New High School for Jordan Springs Proposed New School Armoury Road, Jordan Springs NSW 2747

Report Prepared for: The Department of Education (DoE)
Level 8, 259 George Street
Sydney NSW 2000

Report Prepared by: Lucy Alderson
Our Ref: AN024-016792
Date: 19th December 2024

APPENDIX A – Marked Plans

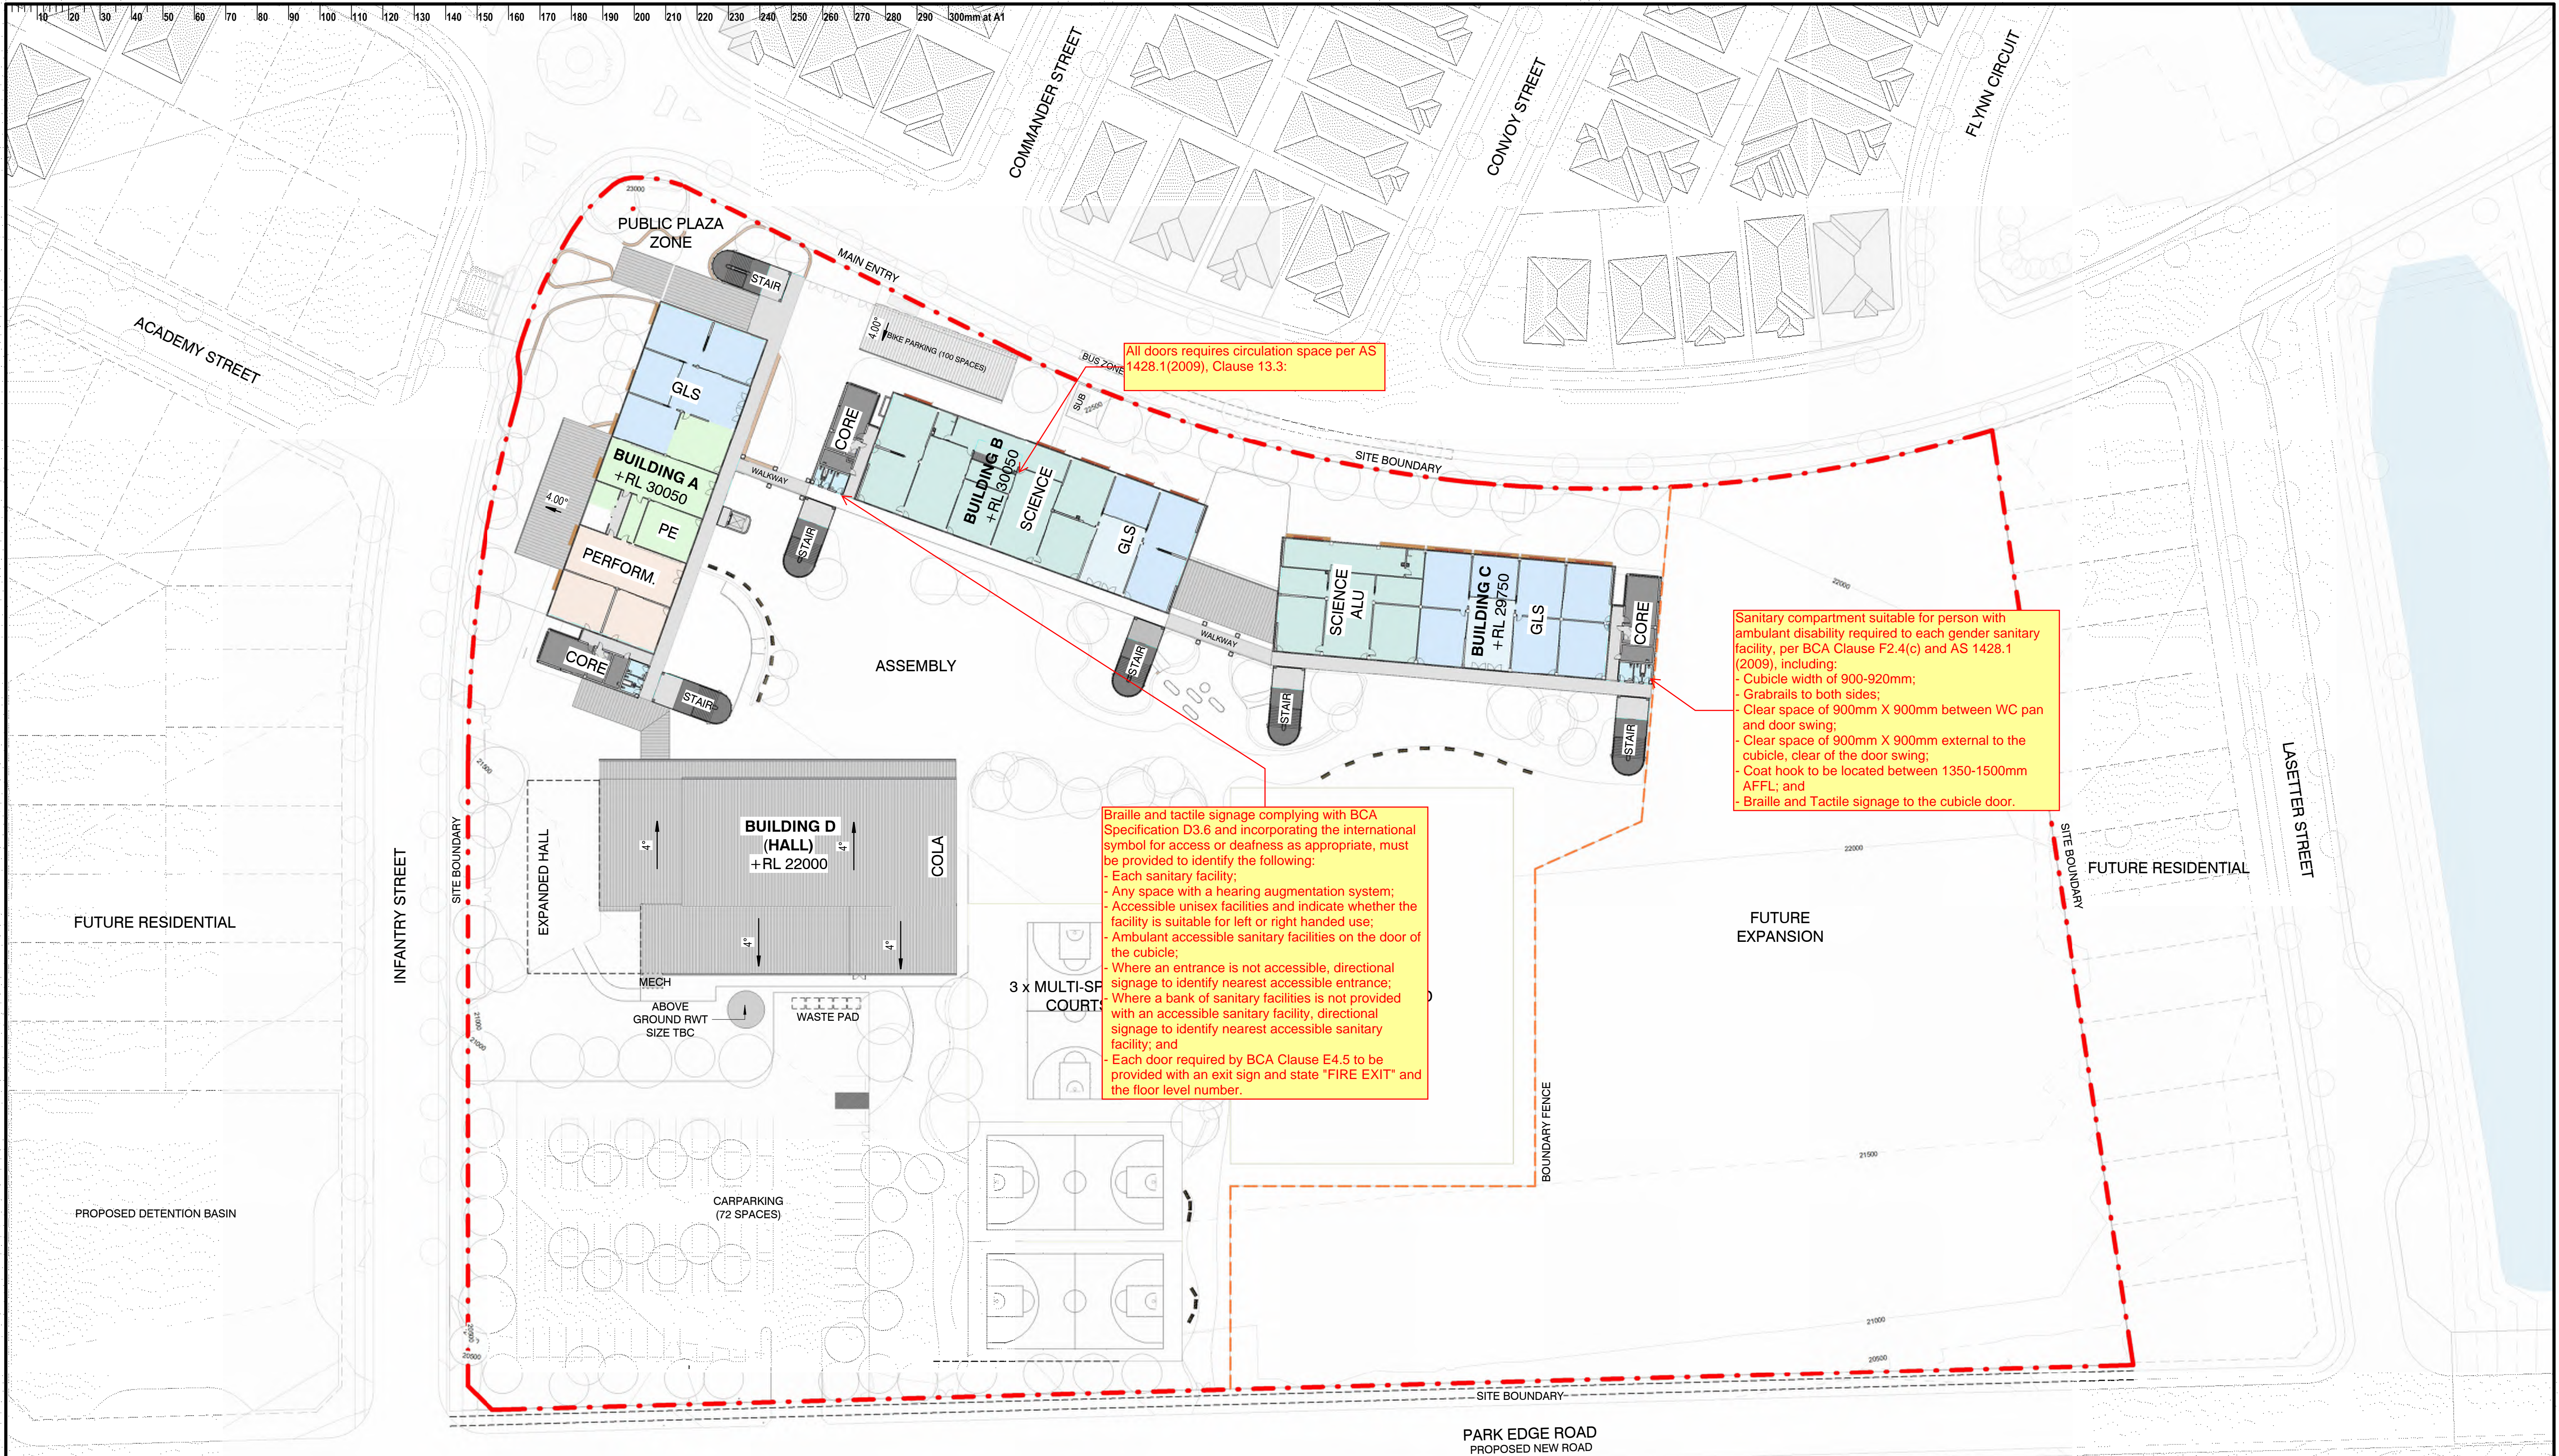
All doors requires circulation space per AS 1428.1(2009), Clause 13.3:

Sanitary compartment suitable for person with ambulant disability required to each gender sanitary facility, per BCA Clause F2.4(c) and AS 1428.1 (2009), including:

- Cubicle width of 900-920mm;
- Grabrails to both sides;
- Clear space of 900mm X 900mm between WC pan and door swing;
- Clear space of 900mm X 900mm external to the cubicle, clear of the door swing;
- Coat hook to be located between 1350-1500mm AFFL; and
- Braille and Tactile signage to the cubicle door.

Braille and tactile signage complying with BCA Specification D3.6 and incorporating the international symbol for access or deafness as appropriate, must be provided to identify the following:

- Each sanitary facility;
- Any space with a hearing augmentation system;
- Accessible unisex facilities and indicate whether the facility is suitable for left or right handed use;
- Ambulant accessible sanitary facilities on the door of the cubicle;
- Where an entrance is not accessible, directional signage to identify nearest accessible entrance;
- Where a bank of sanitary facilities is not provided with an accessible sanitary facility, directional signage to identify nearest accessible sanitary facility; and
- Each door required by BCA Clause E4.5 to be provided with an exit sign and state "FIRE EXIT" and the floor level number.
